[Docket No. NHTSA-2010-0162]

#### Rear Visibility; Federal Motor Vehicle Safety Standard, Rearview Mirrors; Federal Motor Vehicle Safety Standard, Low-Speed Vehicles; Phase-in Reporting Requirements

**ACTION:** Notice of proposed rulemaking; corrections.

Figure 6. Countermeasure Performance Test Area Illustration and Required Test Object Locations

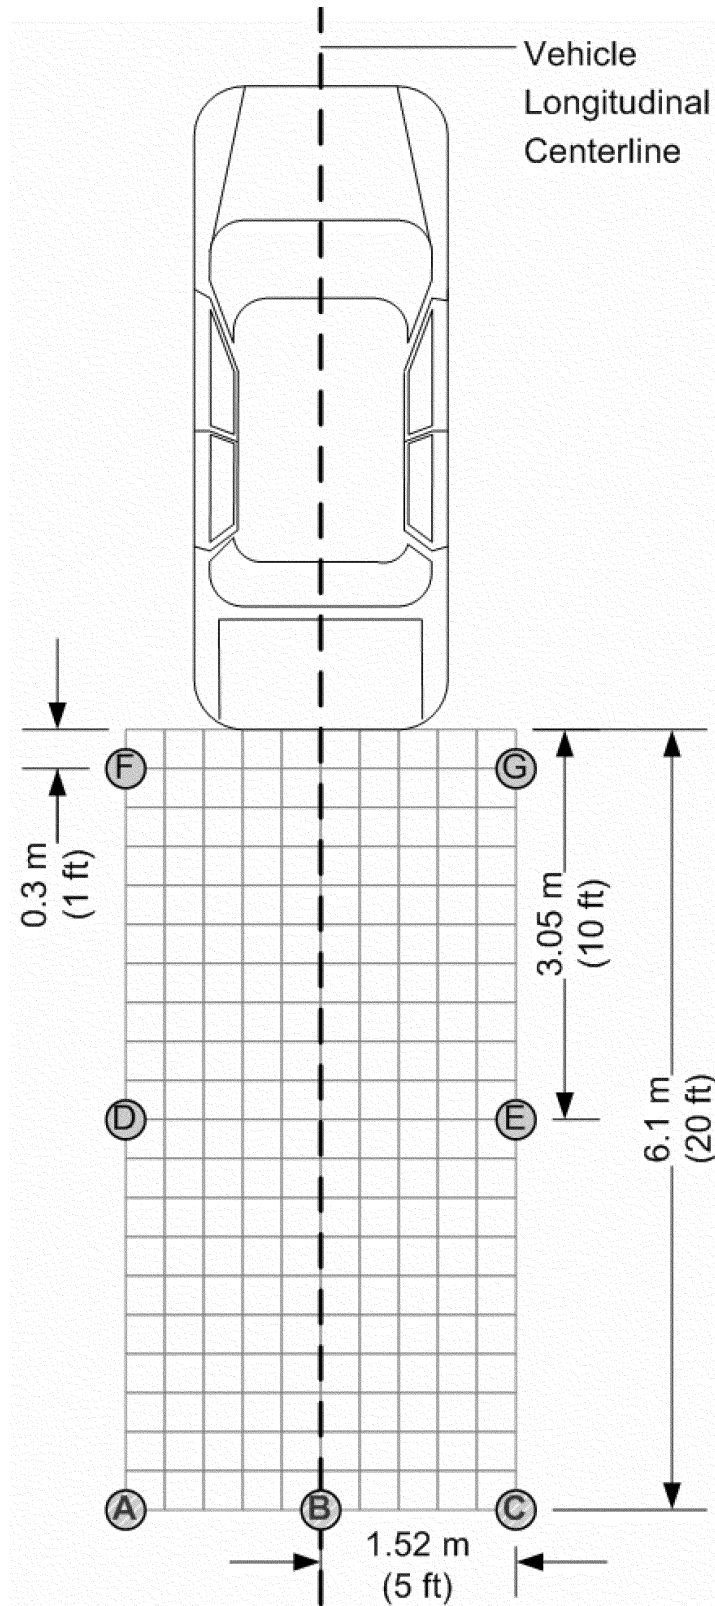
2. On page 76234, figure 6 is corrected to read as follows:

FIGURE 5: TEST CYLINDER LOCATIONS (Units in meters)

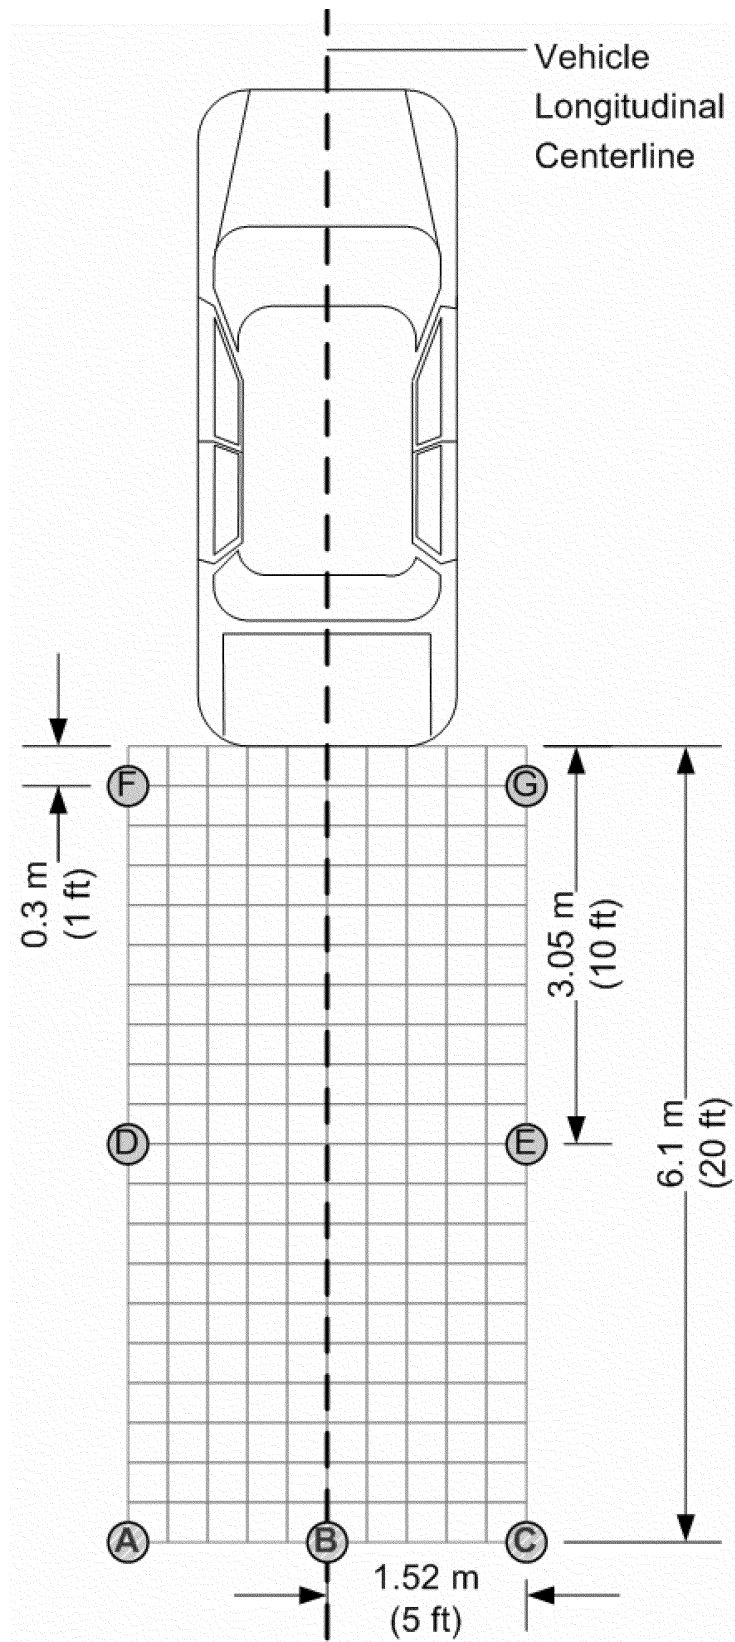
24. On page 76248, Figure 5 is corrected to read as follows:
